Questionnaire 3, Request for Renewal of RoHS Annex IV Exemption 27

“Lead in

Requested renewal period: 7 years

Head endorectal body

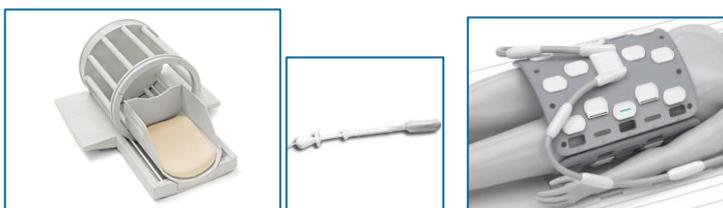
3. You stated that “One model of MRI can be used to examine all parts of the body using many different MRI coils, each MRI coil is used to examine a unique body part or a subset of body parts [...]. To image the entire body, multiple MRI coils are needed.”

Does your above statement mean:

- a. A single MRI device contains several different sending/receiving coils which are activated depending on the respective body part to be examined?

A single MRI scanner is supplied without coils as these are sold separately to hospitals. Each type of coil is plugged into the MRI scanner when it is being used and then disconnected. Coils are located adjacent to the patient’s body or limbs and connected by wires to the scanner. They are stored elsewhere when not needed, far from the MRI as they could interfere with the image quality. Coils are very different in shape and function, from endorectal coils to full body coils.
